Re: Proposed Changes to the Bay Delta Conservation Plan/California WaterFix Continue to Threaten the Delta, Time for Plan "B"

Proposed Changes to BDCP/Cal. WaterFix Continue to Threaten Delta, Time for Plan "B"

Contra Costa County Comments on WaterFix RDEIR/SDEIS**General Comment on the Inadequacy of All BDCP Alternatives**

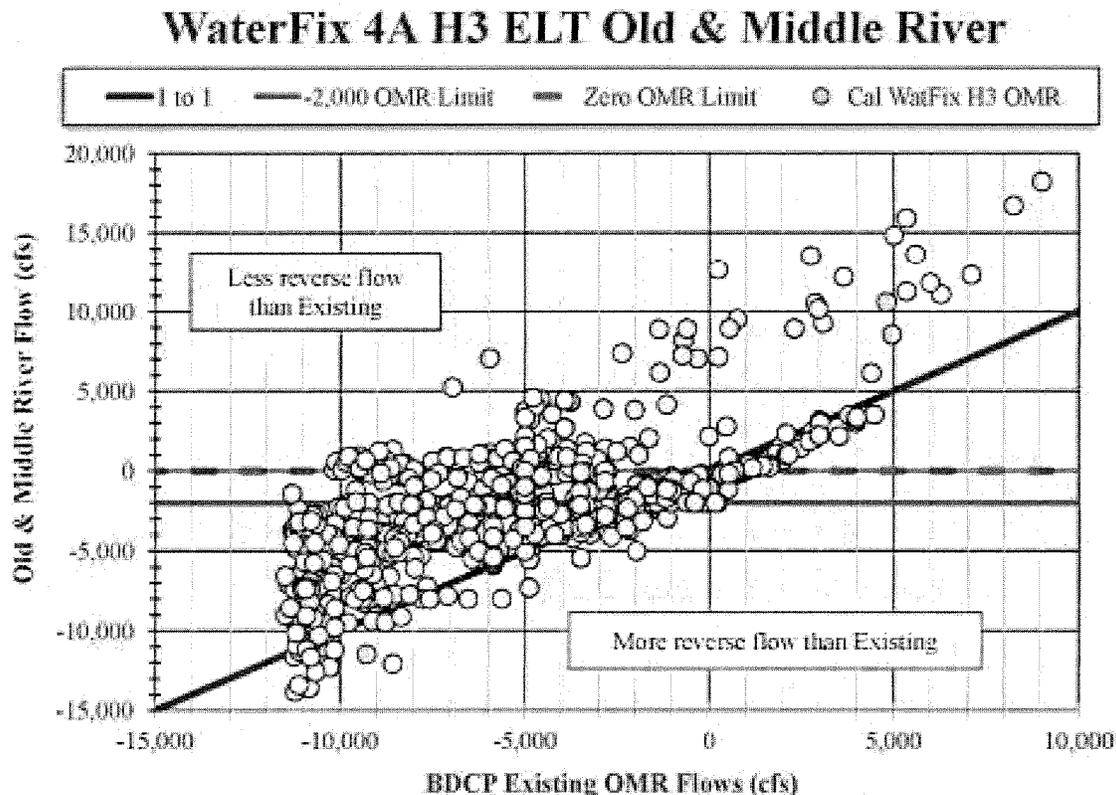
Figure C-8 shows simulated monthly Old and Middle River flows for the WaterFix preferred alternative (Alternative 4A, Scenario H3 at Early Long Term) compared to the OMR flows for the existing basecase, as a scatter plot. Many of the monthly reverse flows are very large in the base case (x-axis) and would remain large even with implementation of the WaterFix preferred alternative with its new north Delta intakes. Some of the existing large reverse flows would get even worse with WaterFix. OMR values of -12,000 cfs in the basecase would worsen to -14,000 cfs and harm resident fish in the Delta. The published claims that the RDEIR/SDEIS and the proposed project will minimize reverse flows are untrue, and could be viewed as disingenuous.

The WaterFix project and RDEIR/SDEIS is inadequate because it fails to minimize reverse flows in the Delta, and fails to clearly disclose these significant adverse impacts on fish in the Delta. A new Draft EIR/EIS must be prepared which includes new alternatives that significantly reduce or eliminate reverse flows and be released for public review and comment.

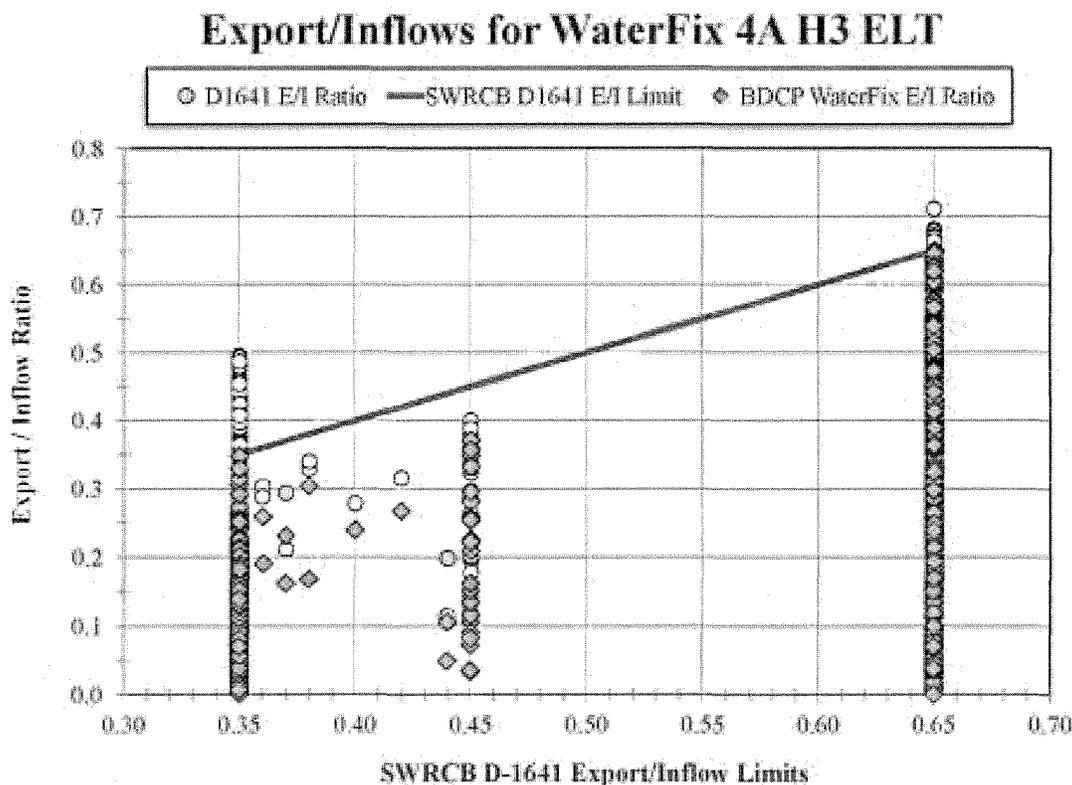
Figure C-9 shows the RDEIR/SDEIS simulations of monthly export/inflow ratios for the WaterFix preferred alternative (Alternative 4A, Scenario H3 at Early Long Term). The export ratios are computed according to the correct SWRCB Water Rights Decision 1641 definition (yellow circles), as well as the faulty definition used in the RDEIR/SDEIS (green diamonds). During periods when the export/inflow is required by D-1641 to be 0.35 or less, the WaterFix project would export almost 50% more water than permitted (E/I as much as 0.5). During periods when an export/inflow ratio of 0.65 is required under D-1641, the WaterFix preferred alternative E/I ratio is as high as 0.71.

A new Draft EIR/EIS must be prepared that analyze alternatives that comply with the SWRCB’s export/inflow standards as well as the existing Army Corps limits on inflow to Clifton Court and the San Joaquin inflow to export ratios in the biological opinions. Additional full model runs could still be included to disclose individual impacts to the Delta ecosystem and water quality if

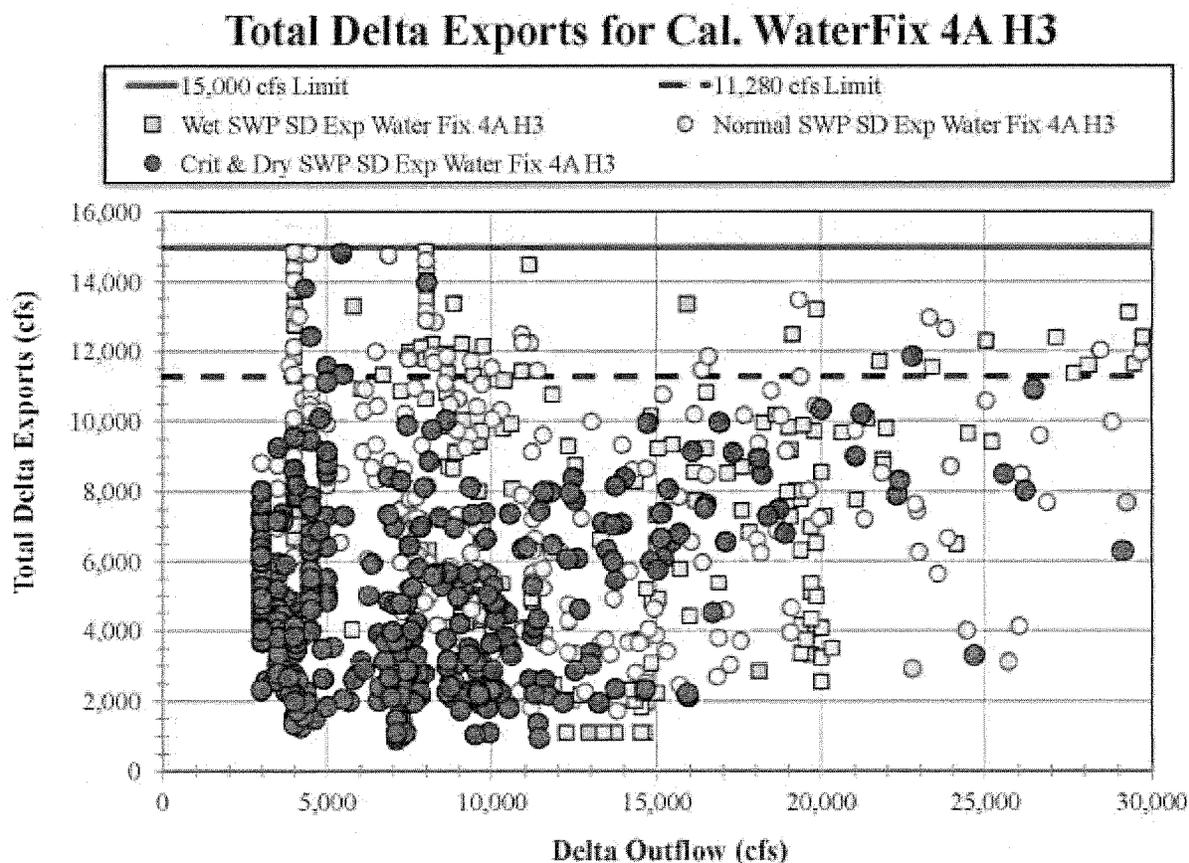
months when Delta outflows are very low (Figure 1, below), i.e., by taking advantage of the increase in maximum export capacity from 11,280 cfs under typical flow conditions and the existing Delta infrastructure, to 15,000 cfs with the proposed 9,000 cfs twin tunnels. This is contrary to the 2009 Delta Reform Act (Water Code section 85021) and threatens already stressed fish species.

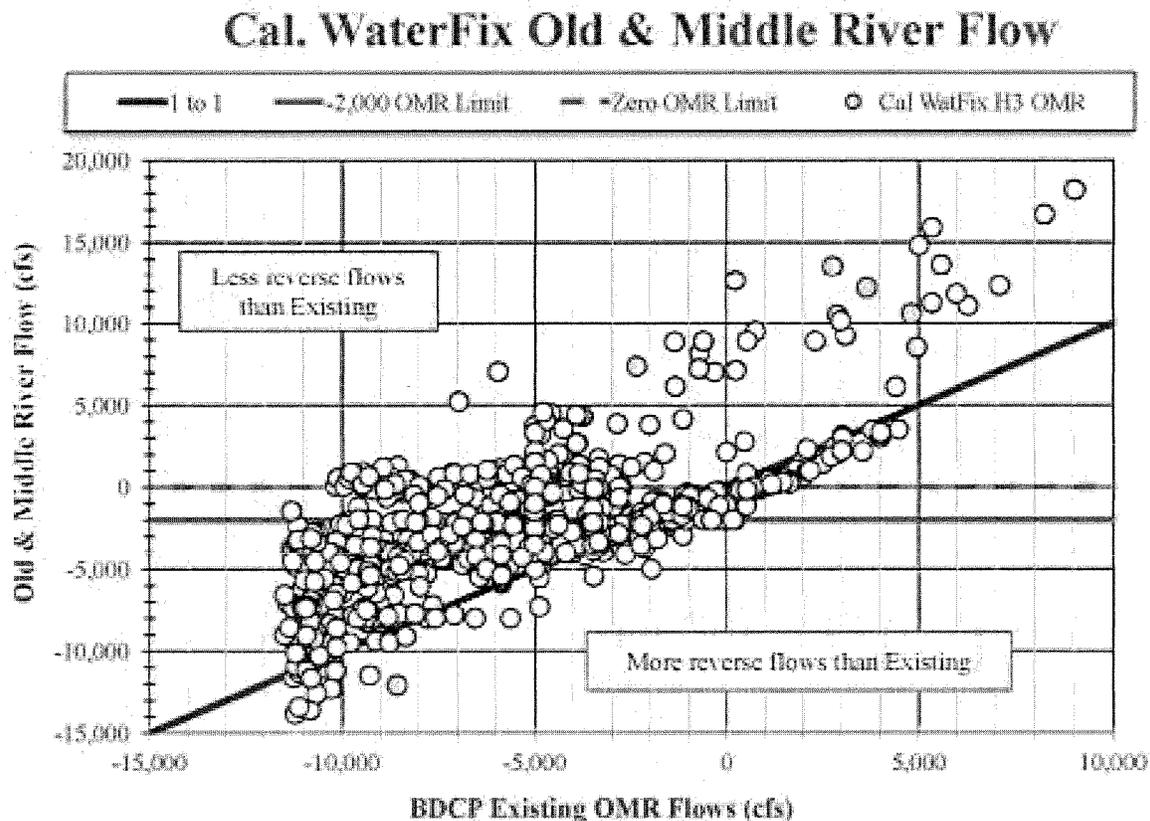
the WaterFix preferred alternative and continued use of the south Delta export intakes for half of the SWP and CVP alternatives does not minimize reverse flows in the south Delta (see Figure 2 below). Fish are resident in the Delta year round. Salvage of other species such as Striped bass, largemouth bass, white cat fish and Mississippi silversides are already large under existing conditions (see Grimaldo et al., "Factors affecting fish entrainment"). This is also likely to be a problem for sturgeon¹. The WaterFix project sets OMR limits for some of the year and will redirect impacts to July, August, September and October. Fish that are resident in the Delta year round may not be declining now, but they will if that period is subjected to increased reverse flows because of the WaterFix project.
